Access Compliance Report

Public Rights-of-Way

(Curb Ramps)

Intersection ID: 47661	Main Street: CANDLESTICK_CT	Cross Street: FENWAY_DR	Location:	SE
ADA ID: 10482D3B8F5F	Ramp Type: BlendTrans1	Initial Pass/Fail: Fail	Overall Compliance: No	Severity Score: 10
Codes/Mitigation Info/Possible Solution		Field Measurements/Component Compliance

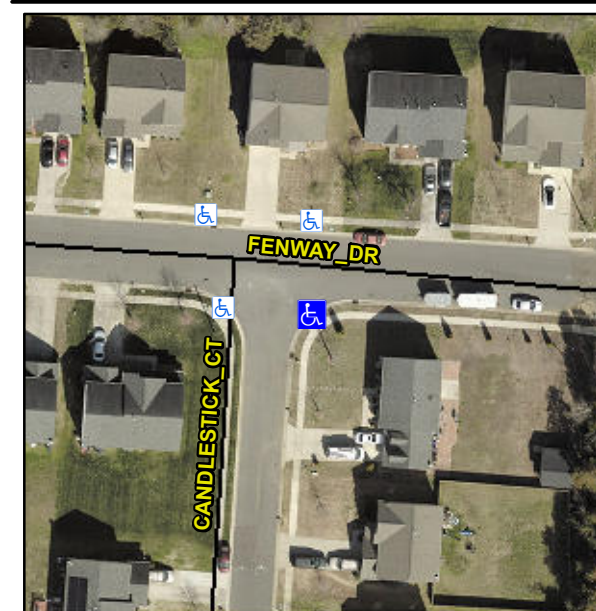
Remove & Replace Curb Ramp With Two New Directional Ramps or Equivalent.

R304.5.1, R304.5.3

Compliance	Description	Data	Compliance	Description	Data
N/A	Ramp Length (in)	52.0	Yes	BlendTrans Slope (%)	2.3
No	Ramp Width (in)	46.0	No	BlendTrans XSlope (%)	2.9
N/A	Flare Type LT	N/A	N/A	Flare Type RT	N/A
N/A	Flare Slope LT (%)	N/A	N/A	Flare Slope RT (%)	N/A
N/A	Flare Traversable LT?	N/A	N/A	Flare Traversable RT?	N/A
N/A	Landing Length (in)	N/A	N/A	DWS Provided?	N/A
N/A	Landing Width (in)	N/A	N/A	DWS Contrast?	N/A
N/A	Landing Slope (%)	N/A	N/A	DWS Length (in)	N/A
N/A	Landing X Slope (%)	N/A	N/A	DWS Full Width?	N/A
N/A	Landing Curb? (Y/N)	N/A	N/A	DWS Offset (in)	N/A
N/A	Shared Landing?	N/A			
N/A	Gutter Ponding?	N/A	N/A	Gutter Slope (%)	N/A
N/A	Gutter Lip Ht (in)	N/A	N/A	Gutter X Slope (%)	N/A
N/A	Painted X Walk1?	No	N/A	Painted X Walk2?	No
	X Walk 1 Direction	To N		X Walk 2 Direction	To W
	X Walk 1 Width (in)	N/A		X Walk 2 Width (in)	N/A
	X Walk 1 Slope (%)	2.5		X Walk 2 Slope (%)	0.6
	X Walk 1 X Slope (%)	1.2		X Walk 2 X Slope (%)	2.1
